May 3, 2023

Re: Bruner Metal Building
4012 2nd St. NW
Traffic Circulation Layout
Architect's Stamp 08-09-22 (G14-D101)

Based upon the information provided in your submittal received 04-12-23, the above referenced plan cannot be approved for Building Permit until the following comments are addressed:

SITE PLAN

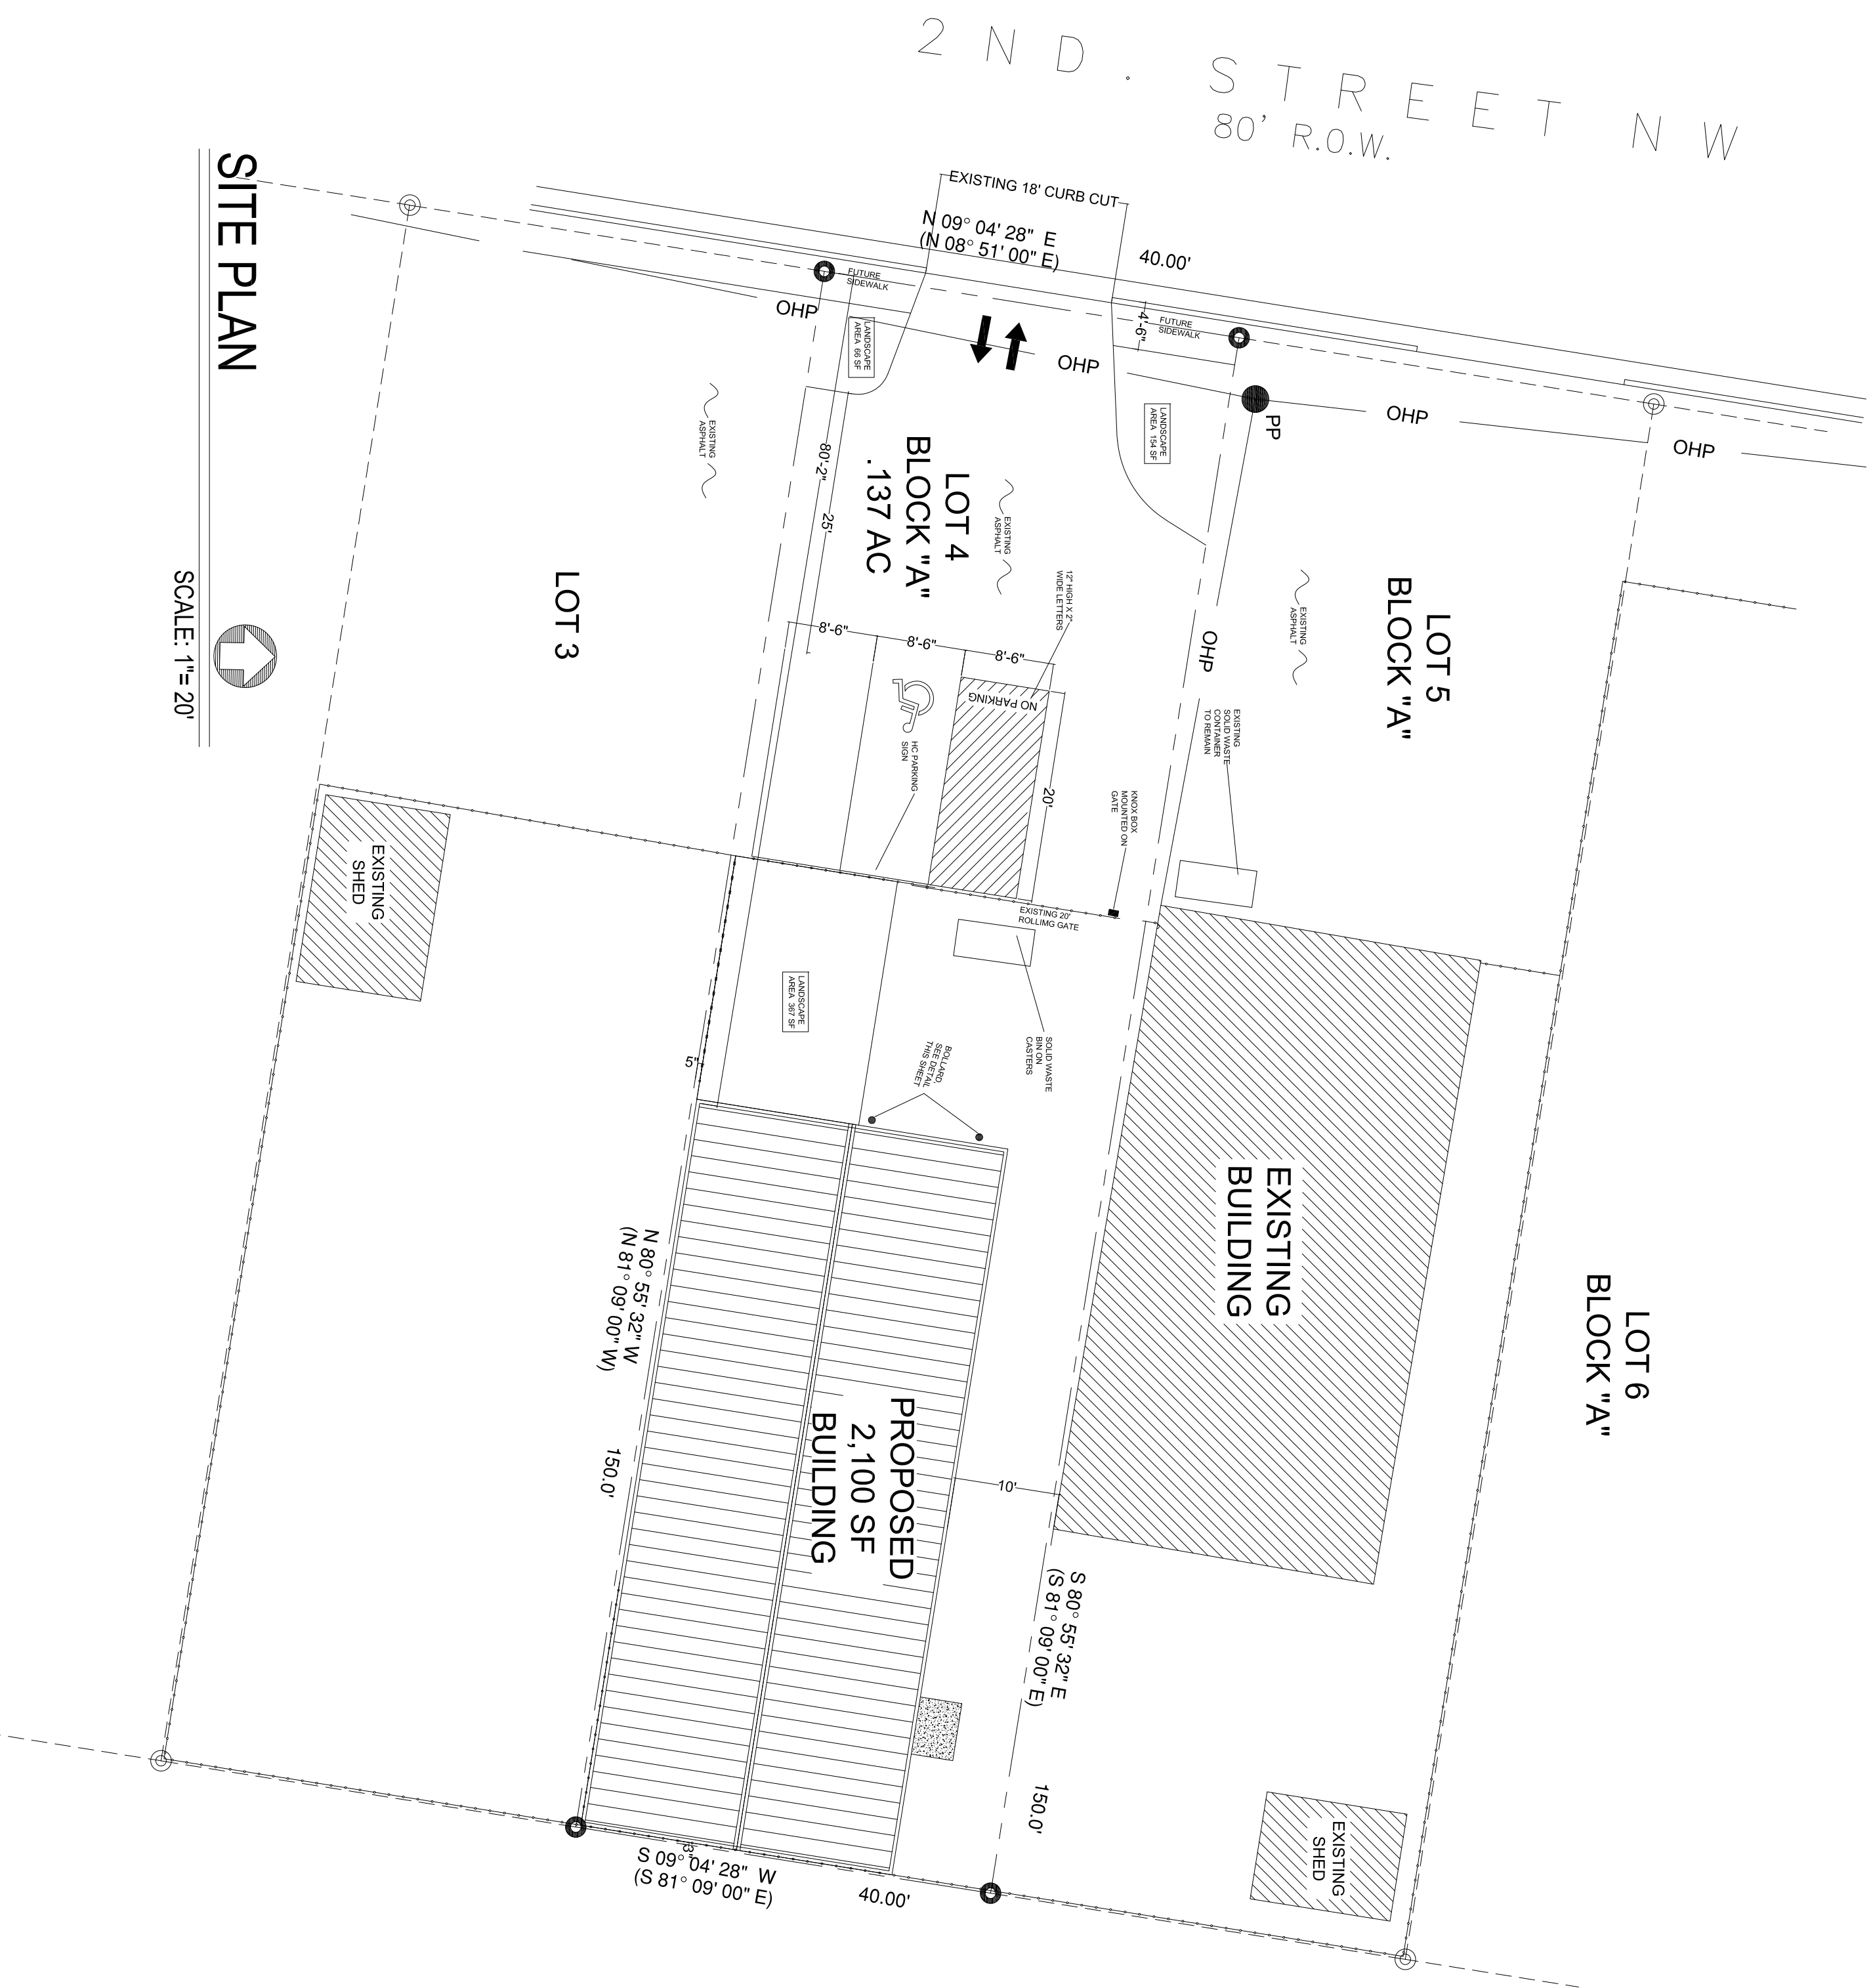
1. List the number of Bicycle and Motorcycle parking spaces required by the IDO.
2. Identify all existing access easements and rights of way width dimensions.
3. Please update the site to the current ADA standard and reference city standard drawing.
4. Sidewalk must be built in front of the site from property line to property line. For sidewalk waviness, please contact Ernest Armijo at (505)-924-3991 earmijo@cabq.gov
5. Is the existing site access used by lot 5 and lot 3? If so, please provide shared access agreement.
6. Maximum access width for arterial, collector, and local streets are as follows:

7. Please note that 2nd St. is classified as Principal Arterial.
8. Motorcycle parking spaces shall be designated by its own conspicuously posted upright sign, either free-standing or wall mounted per the zoning code.
9. The pavement marking "MC" should be shown in the opposite direction for Motorcycles entering the parking space.
10. All bicycle racks shall be designed according to the following guidelines:
 - a. The rack shall be a minimum 30 inches tall and 18 inches wide.

11. Bicycle racks shall be sturdy and anchored to a concrete pad.
12. A 1-foot clear zone around the bicycle parking stall shall be provided.
13. Bicycle parking spaces shall be at least 6 feet long and 2 feet wide.

14. Per the IDO, a 6 ft. wide ADA accessible pedestrian pathway is required from the public sidewalk to the building entrances. Please clearly show this pathway and provide details.

15. Per DPM, a 6 ft. wide ADA accessible pedestrian pathway is required from the ADA parking stall access aisles to the building entrances. Please clearly show this pathway and provide details.

16. ADA accessible pedestrian pathway should not be placed behind parking space or adjacent to a vehicular way. Vehicle and pedestrian/wheel chair conflicts should be avoided as much as possible.

17. Parking areas shall have barriers to prevent vehicles from extending over public sidewalk, public right-of-way, or abutting lots.
18. Refuse vehicle maneuvering shall be contained on-site. The refuse vehicle shall not back into the public right of way.; provide a copy of refuse approval.

19. Please provide a copy of Fire Marshal approval.
20. Show the clear sight triangle and add the following note to the plan: "Landscaping and signage will not interfere with clear sight requirements. Therefore, signs, walls, trees, and shrubbery between 3 and 8 feet tall (as measured from the gutter pan) will not be acceptable in the clear sight triangle.

23. Please add a note on the plan stating "All improvements located in the Right of Way must be included on the work order."
24. Unused curb cuts must be replaced with sidewalk and curb & gutter. A build note must be provided referring to the appropriate City Standard drawing.
